CROSS RIVER RAIL

Environmental Impact Statement

Request for Project Change

February 2017

Figure 6-5 - Changed Project Woolloongabba Station worksite

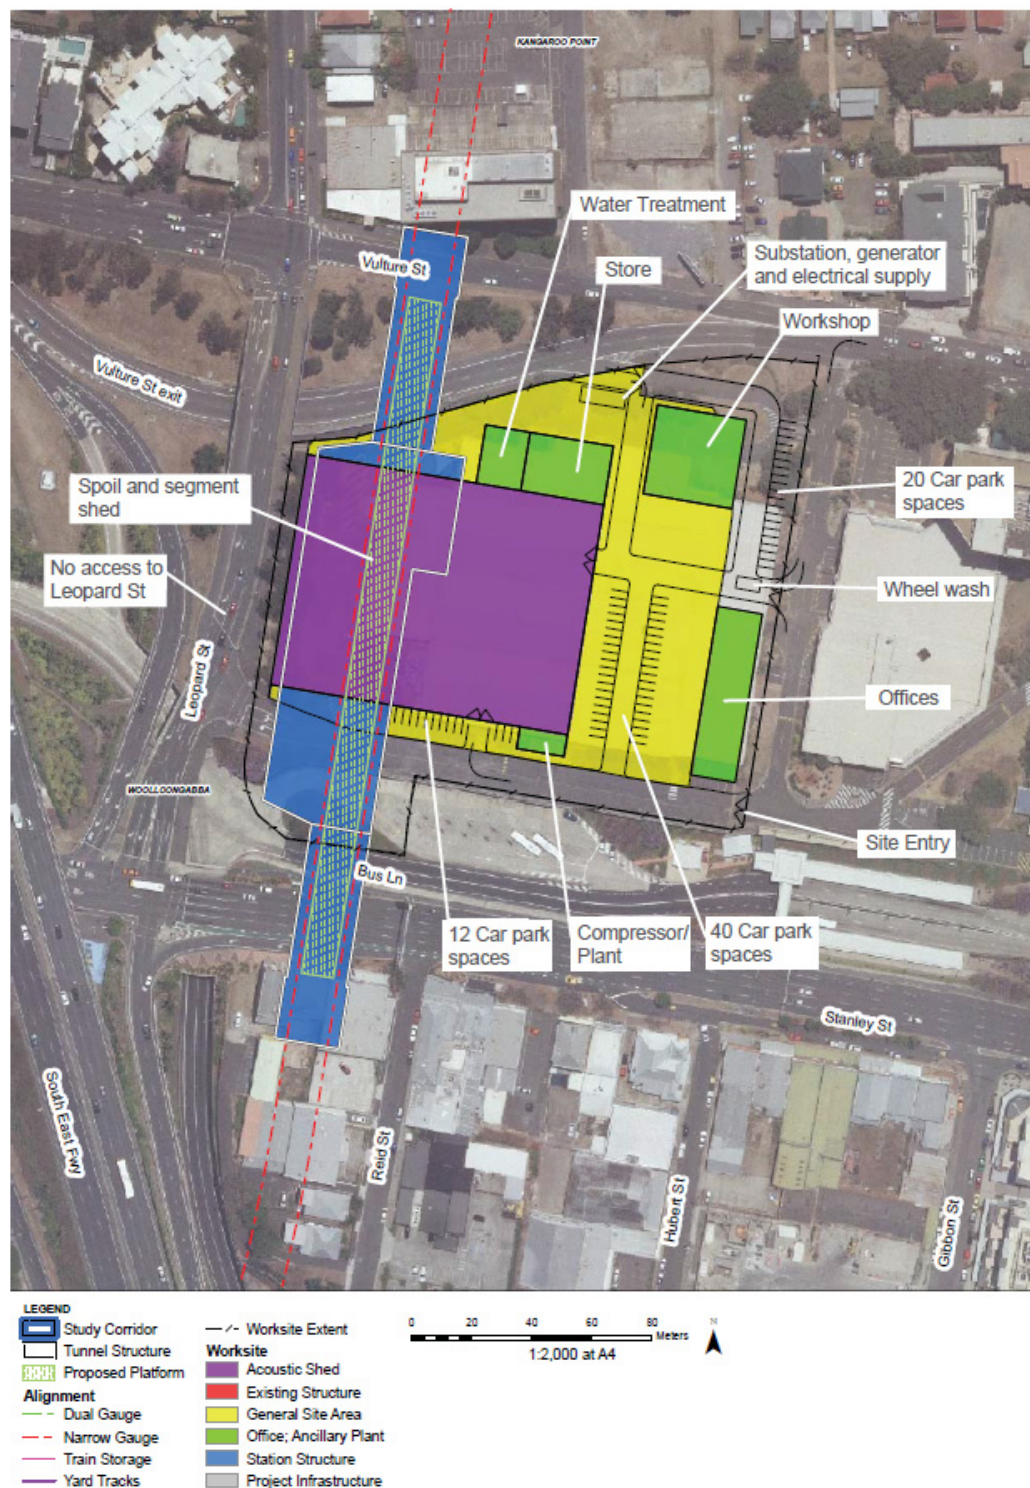
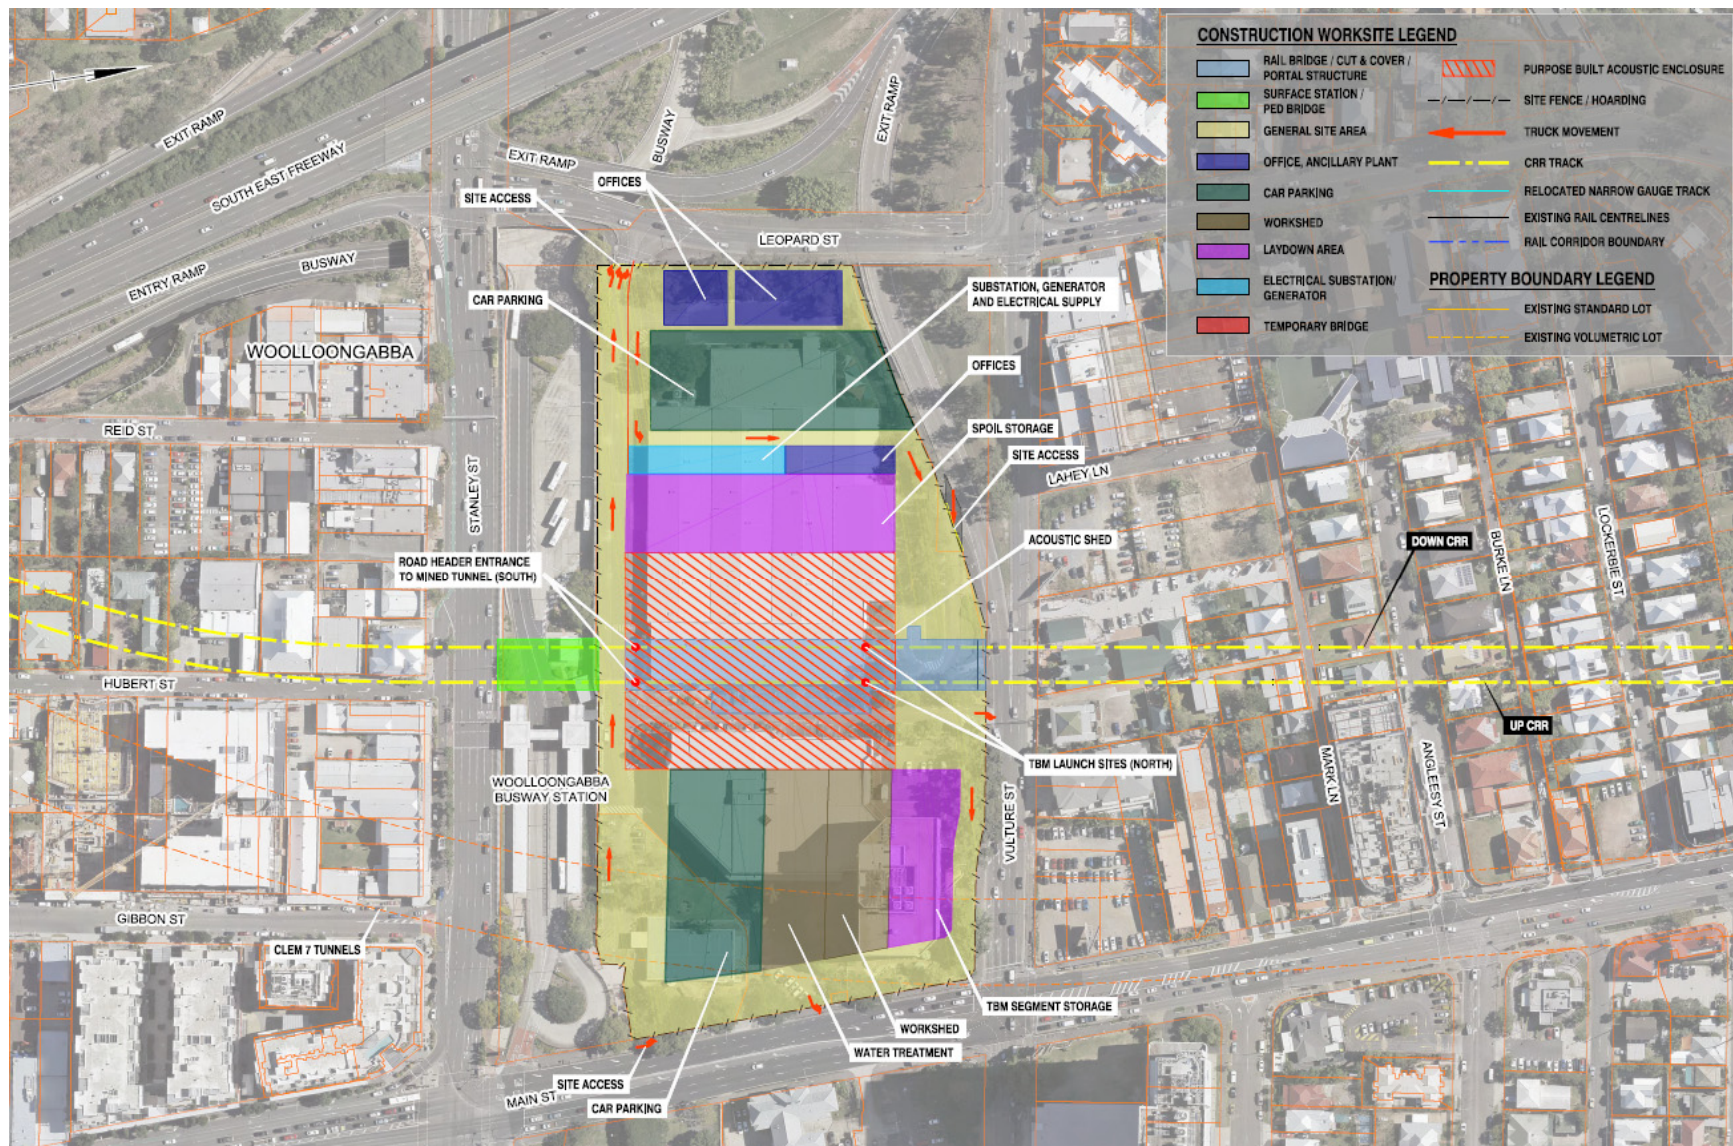
The construction worksites for Woolloongabba Station for the Reference Project and Changed Project are shown in Figure 6-4 and Figure 6-5, respectively.

The Changed Project would provide construction workforce parking for up to 300 cars compared with 72 cars for the Reference Project. This is due to Woolloongabba now being the main spoil removal

Figure 6-7 - Changed Project Albert Street Station worksite

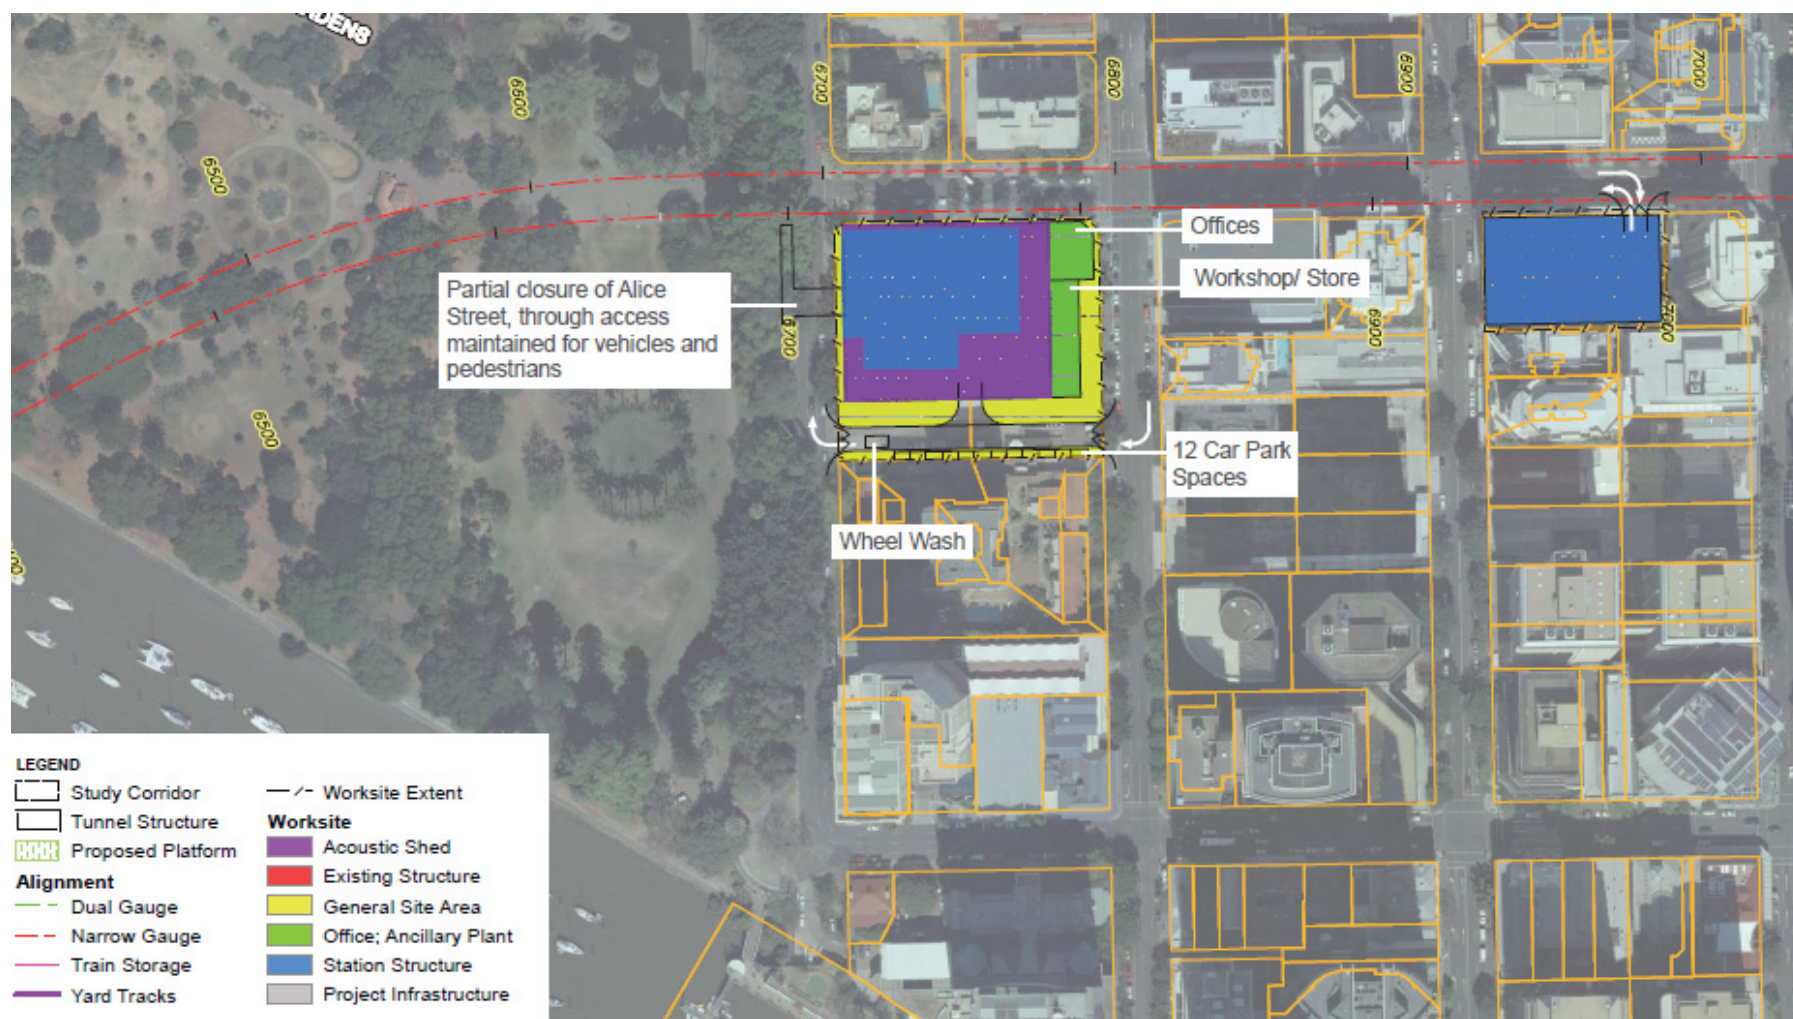
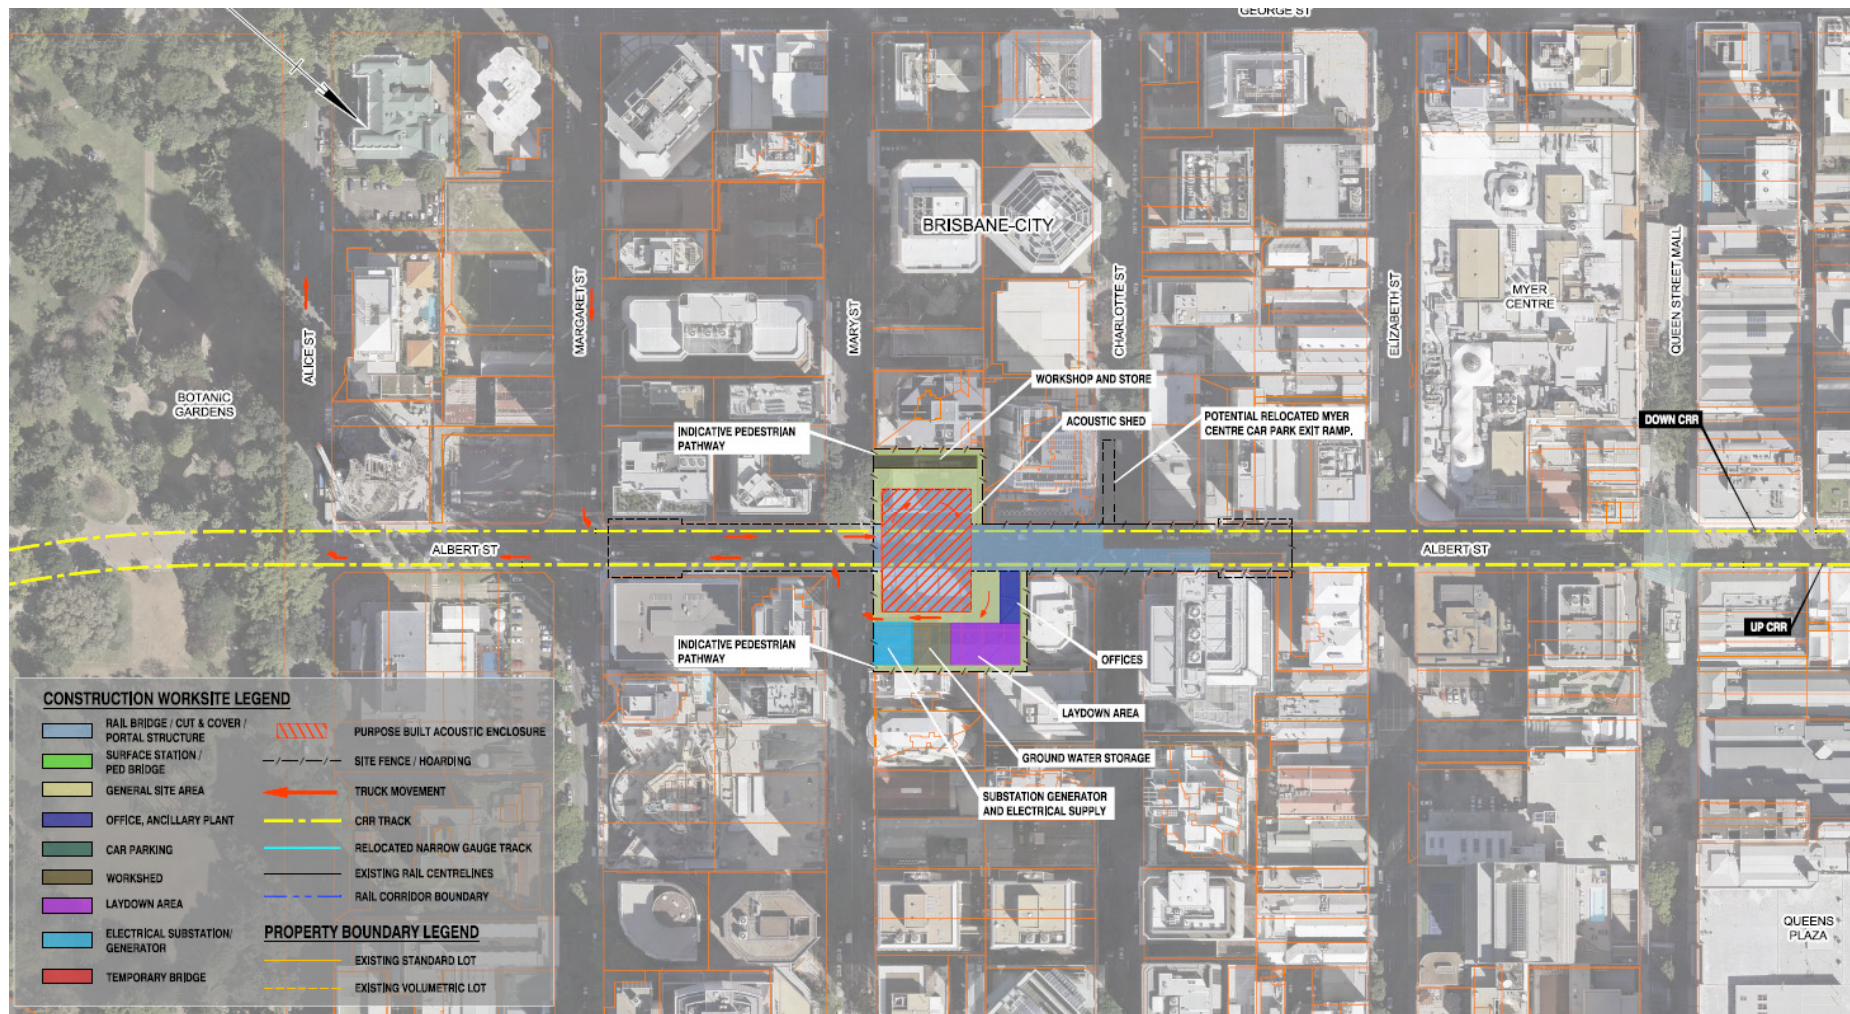
The Albert Street Station worksite for the Reference Project and the Changed Project are shown in Figure 6-6 and Figure 6-7, respectively.

Figure 6-9 - Changed Project Roma Street Station worksite

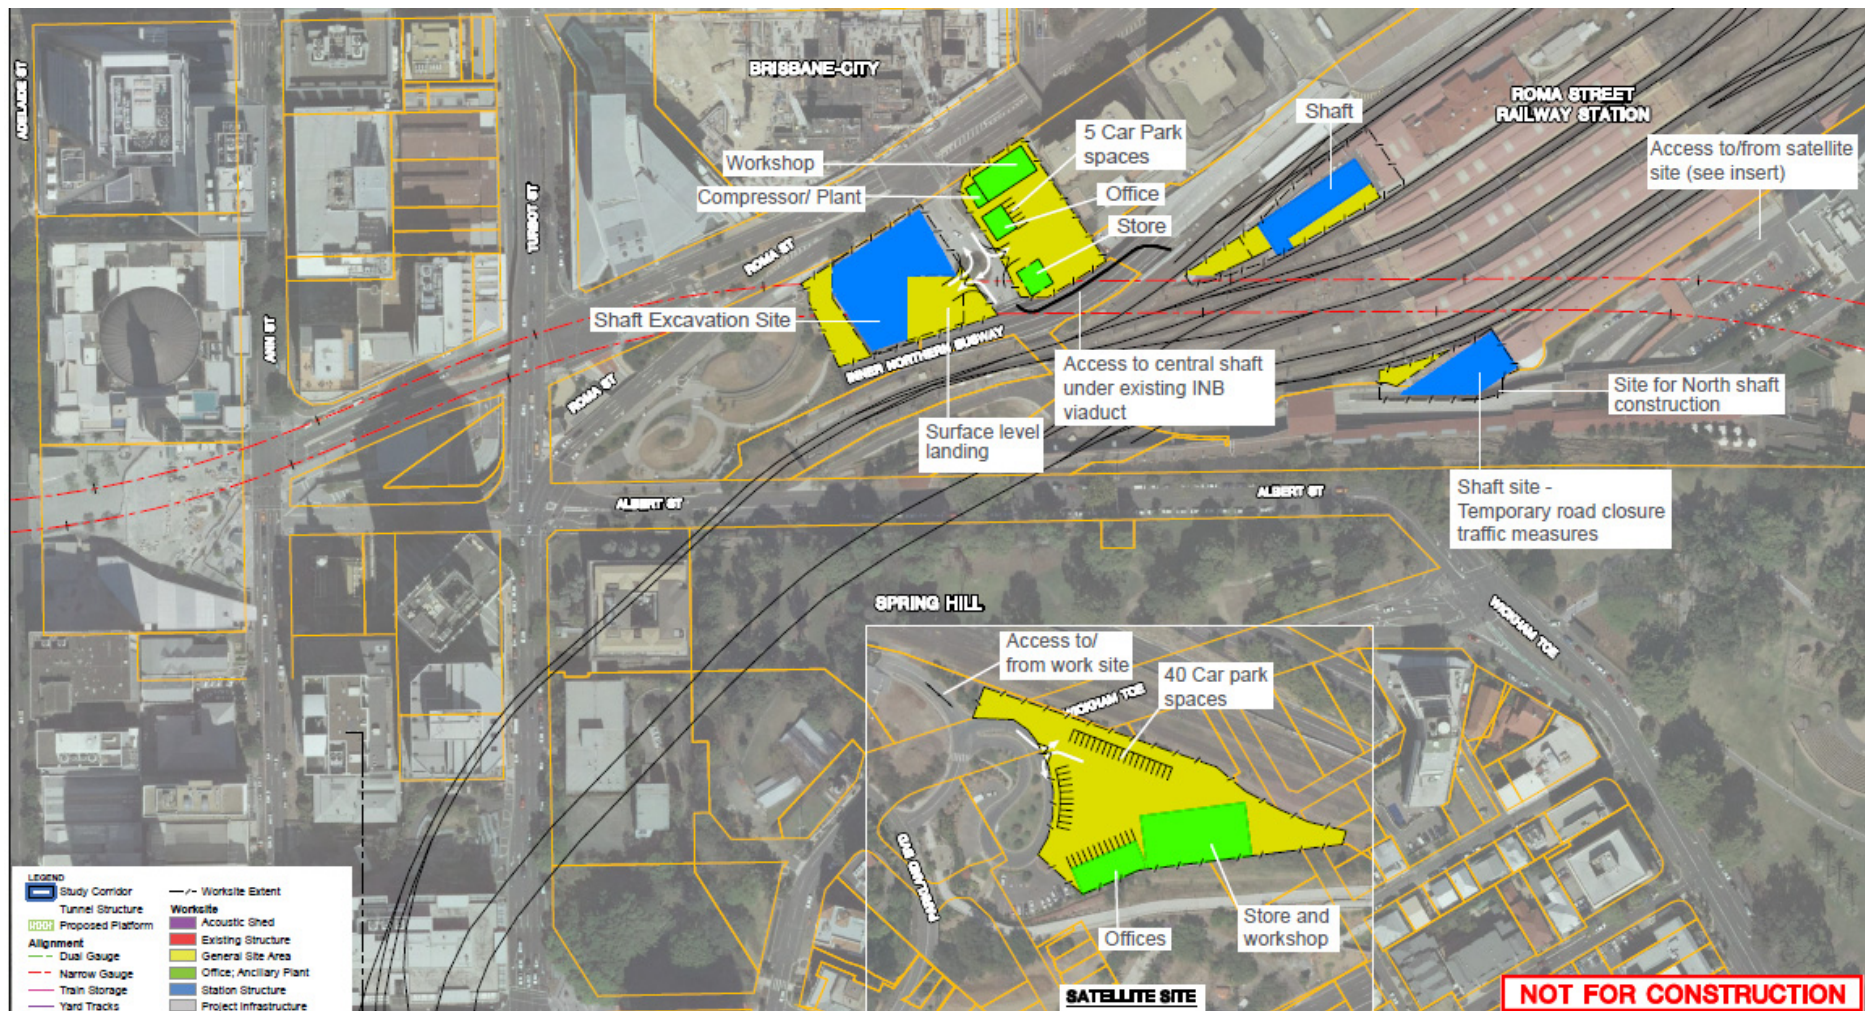
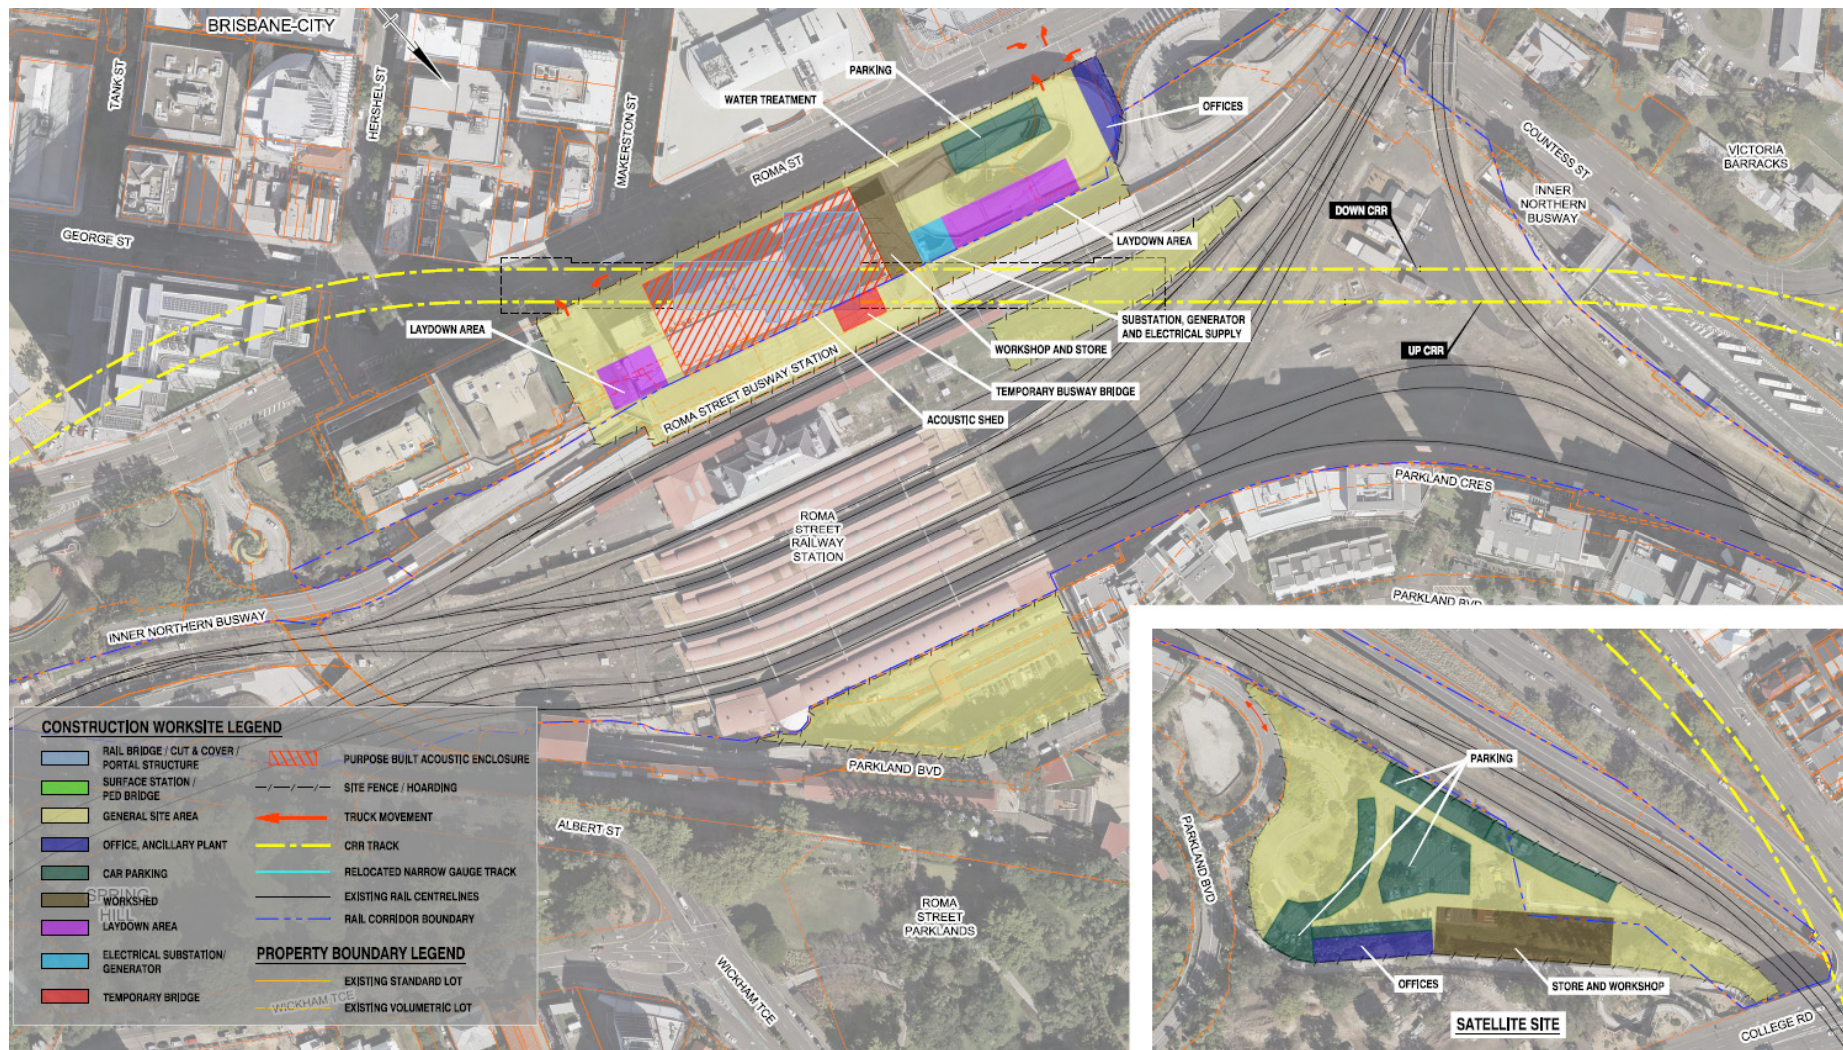
The Roma Street Station worksite for the Reference Project and the Changed Project are shown in Figure 6-8 and Figure 6-9, respectively.

The Changed Project would require the demolition of the BTC (West Tower) and the long-distance coach ramps. There is potential for the demolition works to intercept hazardous materials such as asbestos and possibly hydrocarbons. Consistent with the requirements of the Draft Outline EMP, detailed site investigations will be required to be conducted prior to the commencement of demolition to scope a safe approach to demolition.
